1,239 individual public comments for inclusion in APA's review of APA Project 2021-0075.

Proposed by Thomas Sunderlin and Red Rock Quarry Associates LLC.

PETITION OF CONCERN REGARDING THE WHITE LAKE GRANITE QUARRY

White Lake Granite Quarry Review - Figure 1

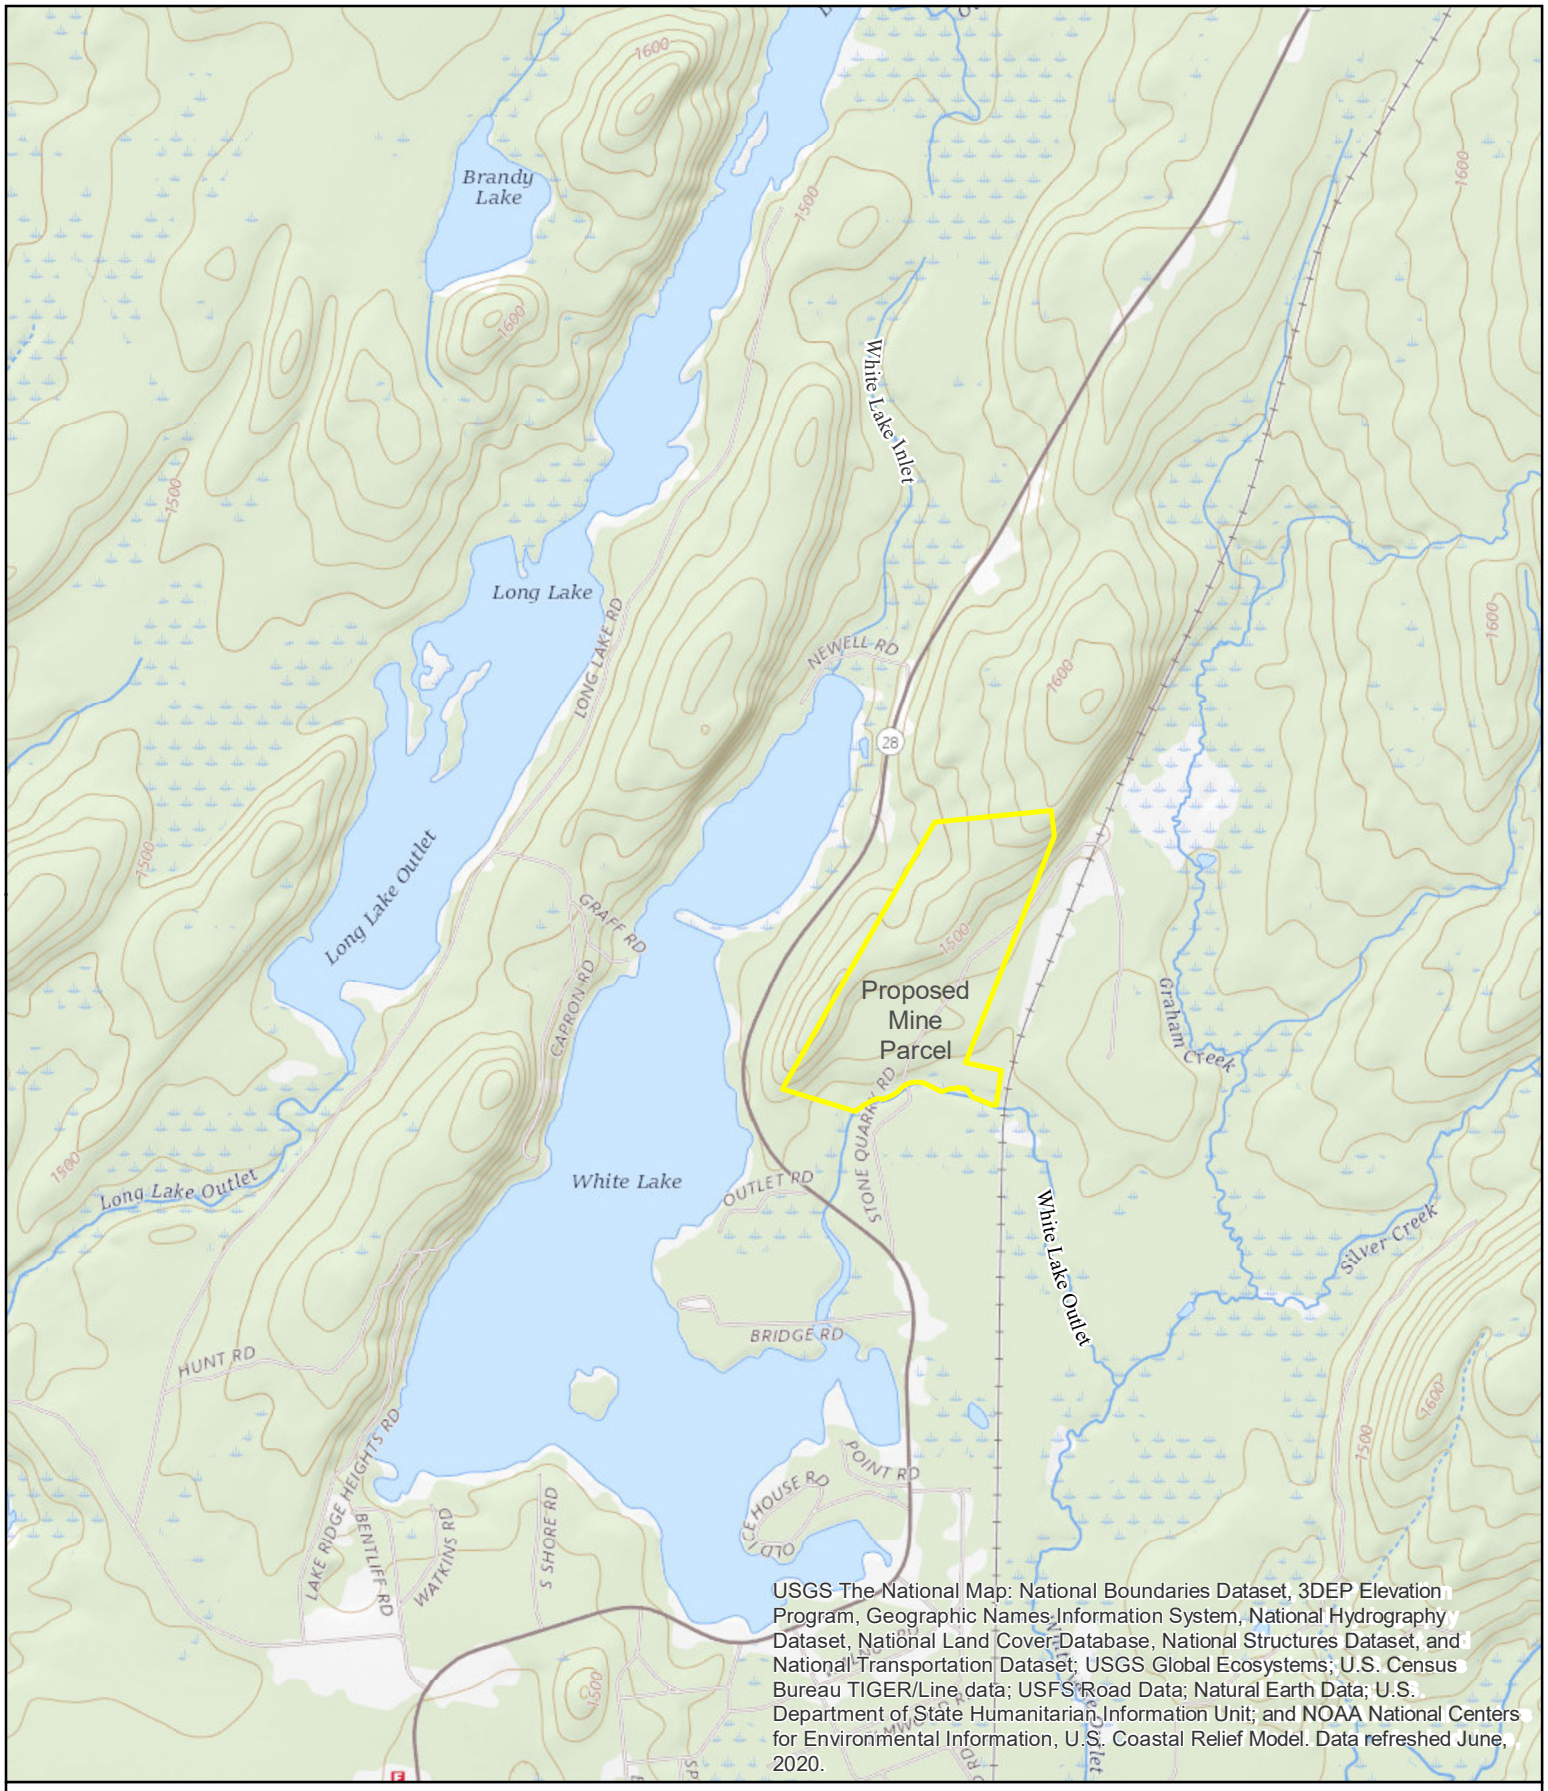
Numerous public comments submitted to date for APA project no. 2021-0075 state that subsurface inflow is a significant component of the water budget of White Lake. USGS mapping of White Lake shows a single surface inlet and a single surface outlet. See Figure 1, White Lake – USGS. Observations of the lake shoreline made from a boat on 7/16/21 did not include observations of any other surface inlets. The inlet of White Lake passes under Newell Road via a 28-inch corrugated metal pipe. The outlet of White Lake passes through two (2) 42-inch ductile iron pipes at Stone Quarry Road approximately 1,900 feet below the beginning of the lake outlet at Bridge Road. Photographs of the inlet and outlet of White Lake are included in Attachment 1 of this letter. Measurements taken at Newell Road and Stone Quarry Road resulted in an approximate inflow of 0.37 cfs and an approximate outflow of 9.61 cfs. These measurements confirm the importance of subsurface flow to the health of White Lake. A primary concern is that proposed mining activities will disrupt the subsurface component of White Lake's water budget which, in turn, has the potential for negatively impacting the current physical, chemical, and biological characteristics of White Lake.

- *Proposed mining operations will occur above the water table in consolidated bedrock*. MLUP p.3
- *Proposed terminal depth of excavation is 1445 ft. roughly 5 to 10 feet above the water table.* MLUP p.4

Figure: 2

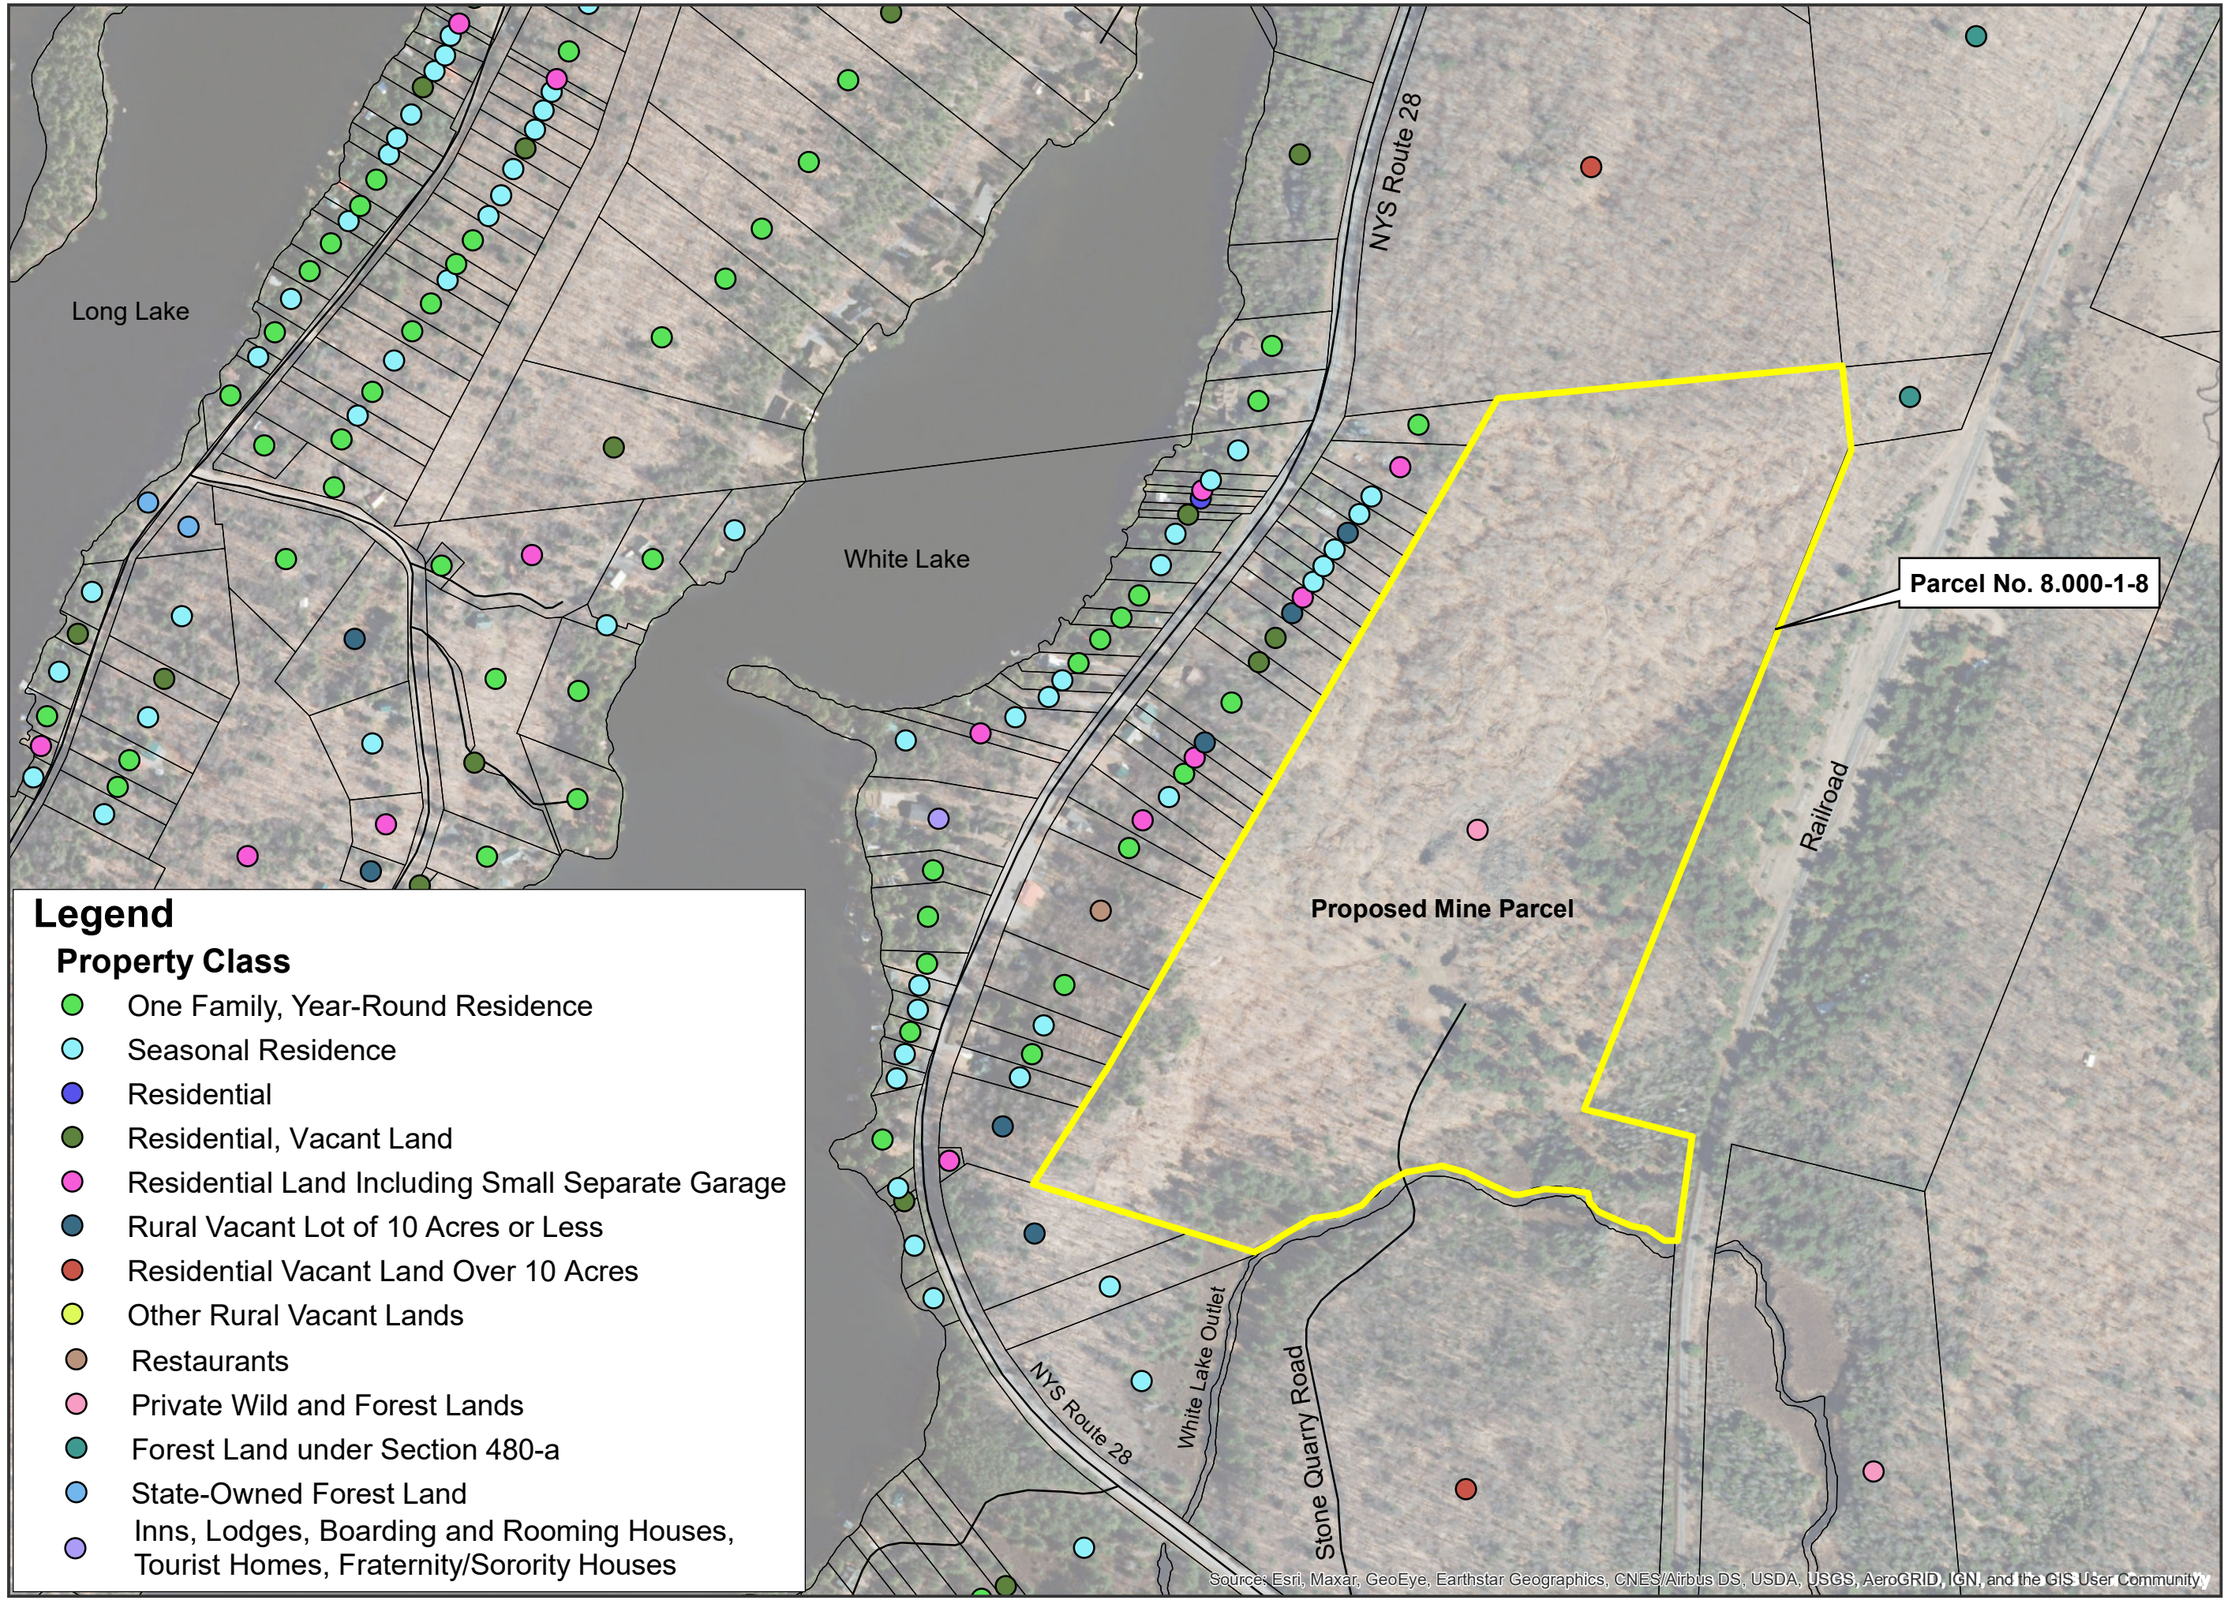
The application correctly states that the noise environment in the closest residential area is dominated by vehicle traffic on NYS Route 28. The MLUP establishes an ambient noise level of 58 dBA based on NYSDOT average annual daily traffic (AADT) data. Because the mine is proposed in area dominated by residential uses (see Figure 2, Nearby Parcel Land Use Classifications), actual ambient noise levels need to be established via measurements taken in proximity to sensitive receptors in the vicinity of the proposed mine. DEC's Program Policy for Assessing and Mitigating Noise Impacts (page 11) states: *Most objective attempts to assess nuisance noise adopt the technique of comparing the noise with actual ambient sound levels or with some derived criterion.* The proximity of the mine to nearby concerned landowners (under 600 feet for some) dictates that collection of sound data is imperative to the review of this project. The DEC Noise Program Policy then goes on to state *If there is any concern that levels based on performance values do not correctly reflect sound pressure levels, field measurements should be undertaken to determine ambient*

[5] Jurisdictional determinations/confirmations of delineated wetland boundaries by APA, DEC and the US Army Corps of Engineers are typically only valid for a certain period of time, oftentimes 5 years, from the agency acceptance of the delineation.
